Service Bulletin

Bulletin No: SB-0001-18-184-SW Effective Date: 07-03-2018

Subject: 12&24V Potted SW350 SCR Charge Controller issue when a remote sensor is installed.

Fig. No. 1

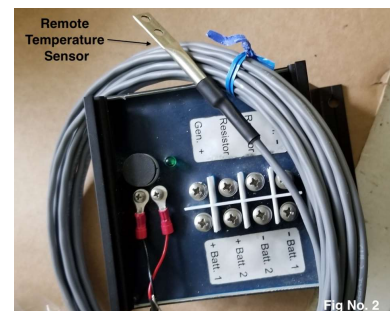
Troubleshooting revealed that in all cases, the customer was using a remote temperature sensor and although the sensor was installed correctly, one or both of the two (2) screw contacts for the sensor were not making proper contact. In each case the customer had failed to utilize the included flat washer provided for use below the friction/lock washer for each screw (Fig. No. 1). Further investigation revealed that the depth of the screw holes was insufficient without use of the flat washer, preventing the screw head from fully seating the connected remote sensor leads. When tightened, the screws “bottomed out” giving a false impression that the screws were fully seated and that a proper connection was made. Once the flat washer was reinstalled, it allowed the screw to tighten down on the remote sensor wire connection and the SRC charge controller and remote sensor operated properly.

Upon comparing older and newer model SW350 SCR Charge controllers, it was found that while the two (2) temperature sensor screws were the same length, the depth of the screw seats (holes) were significantly different. The new SCR Charge controller holes are between 8.9 to 10.5mm in depth, whereas the older units ranged from 15.0 to 15.3 mm.

When installing a temperature sensor (remote or standard), ensure the provided flat washer is properly installed beneath the friction washer on each sensor connection screw to ensure a proper connection (Fig. No. 2).
